# Service Bulletin

**SUBJECT:** Service Update for Inventory and Customer Vehicles  
Body Harness Contact with Park Brake Bracket  
Expires with Base Warranty

**MODELS:** 2014-2015 Chevrolet Silverado  
2014-2015 GMC Sierra

Subject: 14725 – Service Update Bulletin  
Body Harness Contact with Park Brake Bracket

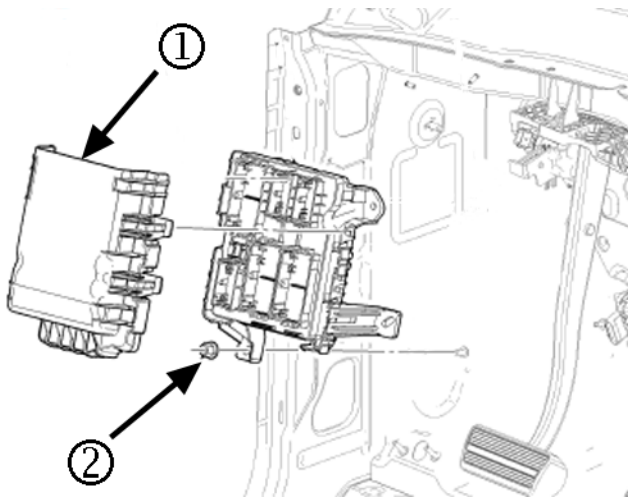
1. Remove the body wiring harness junction block cover (1) located on firewall, right of the park brake assembly. Pull the tabs on either side of the cover to remove.
2. Remove the nut (2) from the junction block bracket.

3. Position the junction block away from the park brake.

4. Locate the fork (1) of the BCM break-out harness from the body harness.
5. Secure the break-out harness away from the park brake bracket by adding the tie strap (2), approximately 25 mm (1.0 in) above the fork.
6. Verify the increased clearance between the harness and the park brake bracket.

7. Reinstall the junction block and install the nut (2). Tighten the nut to 9 N\*m (80 lb in).
8. Reinstall the body wiring harness junction block cover (1).
